# Bloxham Parish Council wish to register their objection to the following Planning application.

25/01009/OUT - Land East of Barford Road Bloxham.

Outline Planning permission for up to 120 dwellings with access off Barford Road.

Photos showing narrow paths on route from proposed development to village centre:

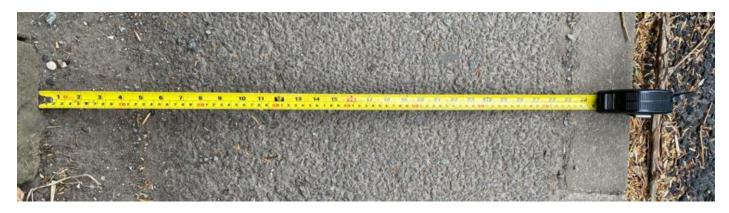
A361 Church Street, pavement width 90cm min, with the additional safety issue of narrow road

Barford Road, old railway bridge 100cm min, with the addition safety issue of narrow road

A361, Memorial Green to Red Lion 80cm min, with the additional safety issue of narrow road

Measured width on A361, Memorial Green to Red Lion, wall to kerb.
